VEHICLE RECALL

IC CORPORATION RECALL # 02302
NHTSA RECALL # 02V-200

SUBJECT: VEHICLE RECALL
RE STEPWELL JOINT

Example Showing Repair to the Forward Joint By Adding Screws

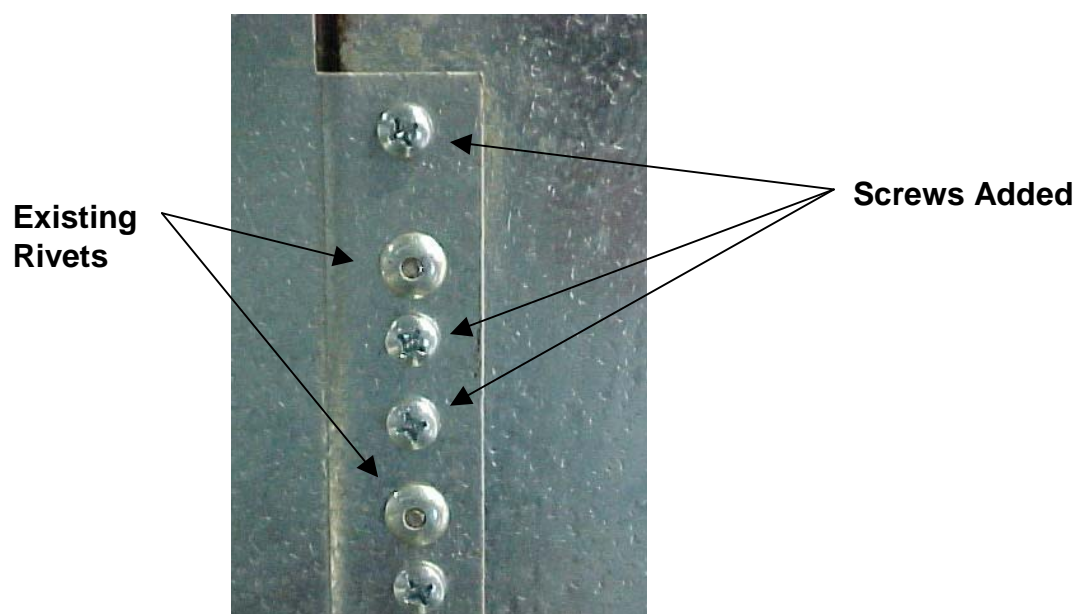
On some of the subject RE buses, if the vertical joints on the forward and rear side of the stepwell are assembled with rivets only, at a spacing of about two inches, the stepwell is incorrectly assembled and will not meet joint strength requirements per the above regulation. See pictures below that show the location and types of the joints.

The customer was told, if the joint is assembled with rivets spaced at approximately two inch increments (no additional screws or rivets) the joint must be repaired (reference Picture # 1). Follow the repair procedures stated below.

This repair procedure involves adding approximately 26 screws, (13 per side) to the vertical joints. No special tools are required. Pilot holes must be drilled prior to installing the screws using a 3/16-inch (#10) bit. Screws are to be located as follows. Insert one screw approximately 1 inch above the top rivet but no closer than about ½ inch from the top edge of the metal piece on the forward joint and not to interfere with the floor trim piece on the rear side of the stepwell. Then insert two screws evenly spaced between the existing rivets.
